ADDENDUM to the Contract for the

Statter Harbor Improvements Phase III(D) Upland Improvements Contract No. DH25-023

ADDENDUM NO.: ONE

DATE ADDENDUM ISSUED: April 25, 2025

ES100

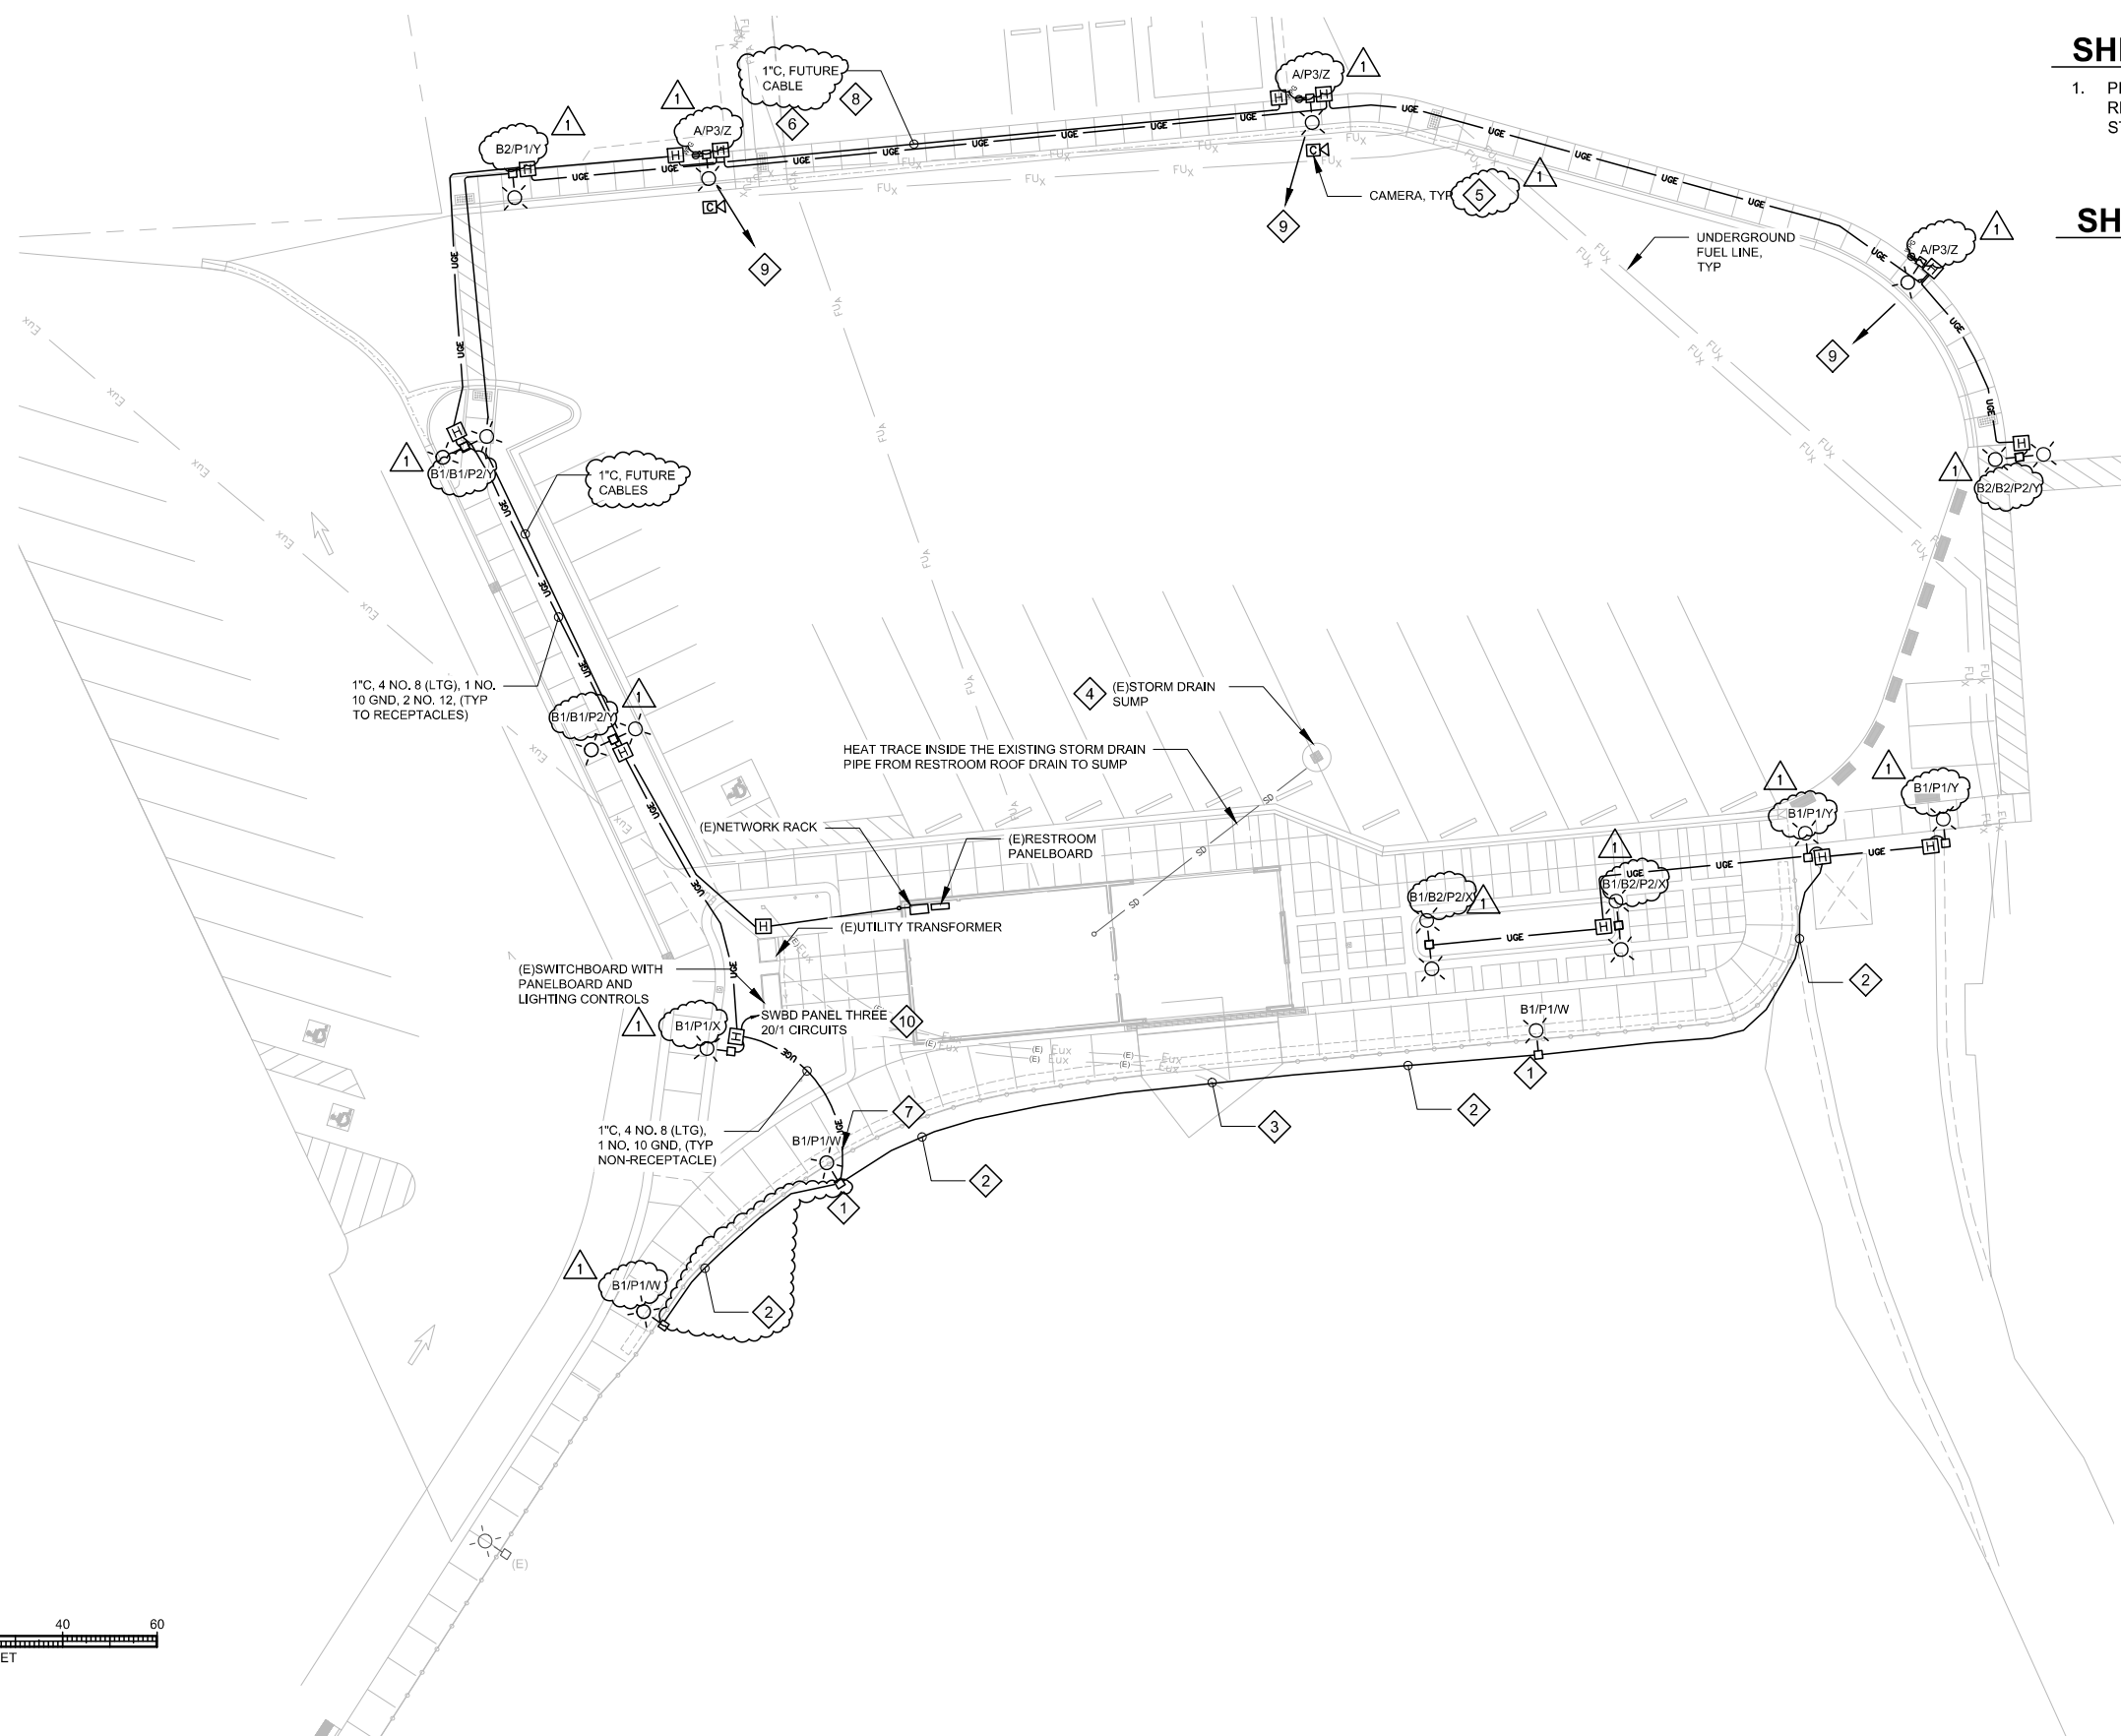
Question No. 2: *"Note 1, Sheet ES100 indicates a Type W base for the two poles closest to the water. Please confirm that Type W is intended as shown on 2.04, Detail C? It is not identified as such on that sheet."*

Question No. 3: *"Pole details 3 and 5 on sheet E501 appear to indicate 3 different base designations. These do not appear on site plan sheet ES100, beyond the two Y bases at the kayak ramp. Please confirm which base is desired for the rest of the poles shown throughout."*

Question No. 4: *"The two B1 fixtures on Y bases at the kayak ramp do not appear to have a pole designation identified. Please confirm which pole is desired for these."*

- Response: The detectable tiles are called out in the notes for the Sidewalk Ramp with Landing detail on sheet 2.07 and measured under 3303.2
- Question No. 8: *"Can you advise the pole type for the two luminaries at the south corner of the project?"*

- Response: The requirement for Cat 6 cables is deleted from the drawings. Refer to the attached revised Sheet ES100 with revisions dated 04/24/25.
- Question No. 11: *"Can you identify the foundation types for light poles that do not have foundations indicated on ES100 (11 in total)?"*

REVISIONS							
REV.	DATE	DESCRIPTION			DWN.	CKD.	APP.
1	04/24/2025	ADDENDUM 1 ADDS LIGHT POLE FOUNDATION TYPES, CORRECTS KEYNOTE 5

Response: Yes, Type W base matches detail C shown on 2.04.

Response: All poles now have a foundation designation either W, X, Y or Z shown on the amended site plan ES100 with revisions dated 04/24/25.

Response: These two lights will use P1 pole now noted in the amended site plan drawing.

- Response: See the attached Sheet ES100 with revisions dated 04/24/25 for light pole foundation types.
- Question No. 10: *"The max allowable cable length for the structured cabling is listed at 295' in the spec. The conduit routing indicated on the drawings surpasses that for each camera run. Are these conduit runs to be routed differently to accommodate the 295' max run length?"*

- Response: See the attached Sheet ES100 with revisions dated 04/24/25 for light pole foundation types.
- Question No. 12: *"E001 indicates hubs in poles for motion sensors. Are these motion sensors for lighting, security, or is it a spare hub for future use?"*
